Project	<b>IEEE 802.16 Broadband Wireless Access Working Group &lt;<a href="http://iee802.org/16">http://iee802.org/16</a>&gt;</b>	
Title	<b>Reply to comment #5484, contribution 289 "Corrections to fast DL S/N measurements"</b>	
Date Submitted	<b>2005-06-13</b>	
Source(s)	Peiyong Zhu, Wen Tong, Mo-Han Fong Nortel 3500 Carling Avenue Ottawa,	Voice: +1 613 765 8089 Fax: +1 613 765 6717 <a href="mailto:pyzhu@nortel.com">pyzhu@nortel.com</a> ,
Re:	IEEE P802.16e/D8	
Abstract	This contribution suggested a modification of the contribution C802.16e-01/289 in order to address few editorial changes.	
Purpose	Discuss and approve.	
Notice	This document has been prepared to assist IEEE 802.16. It is offered as a basis for discussion and is not binding on the contributing individual(s) or organization(s). The material in this document is subject to change in form and content after further study. The contributor(s) reserve(s) the right to add, amend or withdraw material contained herein.

**Figure 230a—Post processed S/N for MIMO region**

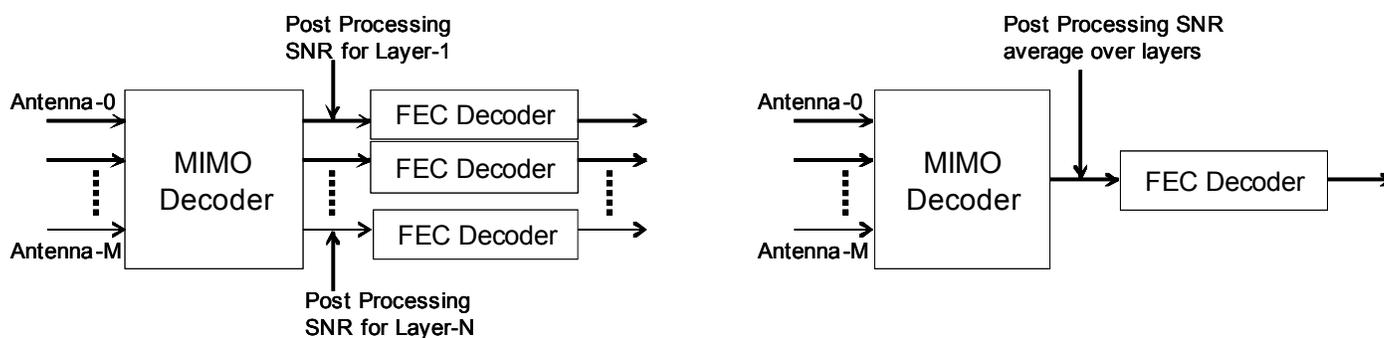
This contribution suggests a modification to the contribution C802.16e-05/289 for comment # 5484 to address some editorial changes. Specifically, I moved the 4 bit S/R reporting to the proper section 8.4.5.4.10.1 and added back the post processing S/N definition diagram, which was in D6 and nor sure why it was removed. (One reason may be that the same contents are added in the corrigenda). However, .16e is an amendment for IEEE802.16-2004 baseline, if people does not read the corrigenda document, then the post processing S/N definition is missing. To be consistent, I added the diagram and made sure that there is no conflict with the corrigenda D3.

MIMO capable SS shall measure post processing S/N for each individual layers as shown in Figure 230a. The SS shall report the post processing CINR averaged over layers. When BS requests SS feedback through CQICH\_Alloc\_IE() SS shall report average S/N or individual layer S/N as described in sections 8.4.5.4.12.
